Item Name: Floor Protector, Aft RH

DRAWING NO. D3281	TITLE FLOOR PROTECTOR	REV. E	DART AEROSPACE LTD ENGINEERING ORDER		D.E.O. NO. D3281-E-1	SHEET NO. SHEET 1 OF 1	SCALE NTS
DRAWN <i>q</i>	CHECKED <i>fl.</i>	MFG. APPR.	APPROVED		DE APPR.		
DATE 10.02.24	DATE 10.02.24	DATE	DATE		DATE

PURPOSE

ADD "D3281-xKCL" MATERIAL OPTION.

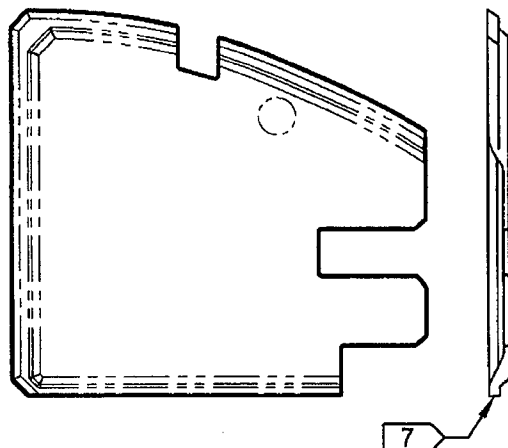
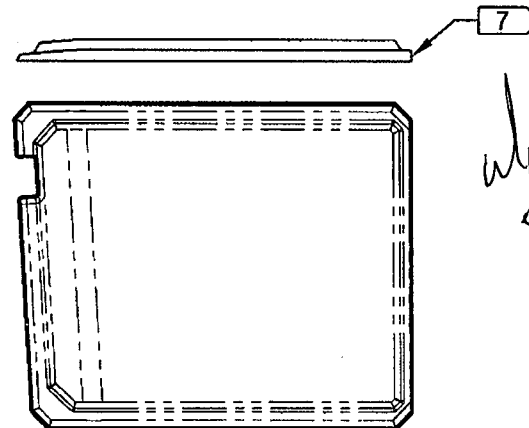
D3281-xKCL PARTS ARE EQUIVALENT TO THE RESPECTIVE "-x" PARTS, HOWEVER THE MATERIAL AND IDENTIFICATION NOTES ARE AMENDED AS FOLLOWS:

2) MATERIAL: LEXAN 90318 (PROTECT-A-GLAZE), 0.118 THICK, 112-CLEAR
(MLEXS.118-90318-08)

7) IDENTIFICATION: IDENTIFY WITH DART P/N "D3281-xKCL" AND B/N "Bxxxxx" ON SMOOTH SIDE OF PART USING VIBRATING STYLUS.
LOCATE ENGRAVING ALONG PERIMETER OF PART.

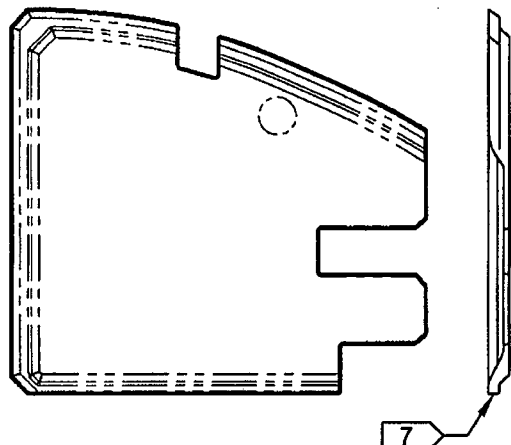
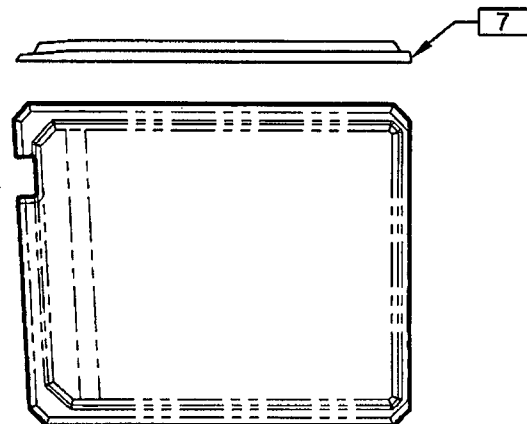
ADD "D3281-xL08" MATERIAL OPTION. EXISTING PARTS TO BE IDENTIFIED AS "D3281-xL02"

D3281-xL08 PARTS ARE EQUIVALENT TO THE RESPECTIVE "-x" PARTS EXCEPT AS DETAIL BELOW. THE MATERIAL, IDENTIFICATION, AND WEIGHT NOTES ARE AMENDED AS FOLLOWS:

- 2) MATERIAL: -xL02 = LEXAN F6006, BLACK No. 701, 0.093" THICK (MLEXS.093-F6006-02)
 -xL08 = LEXAN 90318 (PROTECT-A-GLAZE), 0.118 THICK, 112-CLEAR (MLEXS.118-90318-08)

- 7) IDENTIFICATION: IDENTIFY WITH DART P/N "D3281-xLxx" AND B/N "Bxxxxx" ON SMOOTH SIDE OF PART USING VIBRATING STYLUS.
 FOR -xL08 PARTS, LOCATE ENGRAVING ALONG PERIMETER OF PART AS SHOWN.

- 8) WEIGHT: D3281-1L02/-2L02 = 0.95 lb D3281-1L08/-2L08 = 1.13 lb
 D3281-1L02/-2L02 = 0.87 lb D3281-3L08/-4L08 = 1.05 lb
